**CENTER FOR DRUG EVALUATION AND  
RESEARCH**

*APPLICATION NUMBER:*

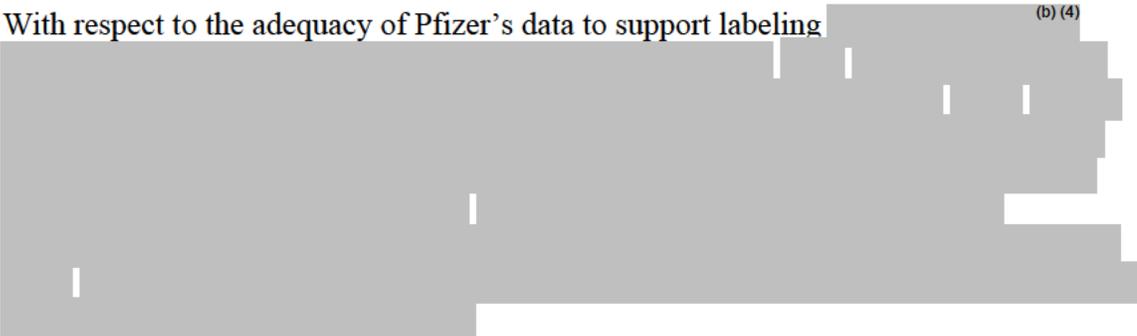
**FDA Response:** FDA does not agree with Pfizer's proposal to submit the data from 5 DP lots as part of the 120 day safety update. However, FDA may request a "simple stability update" during the course of the 351(k) BLA review to enable assessment of data from
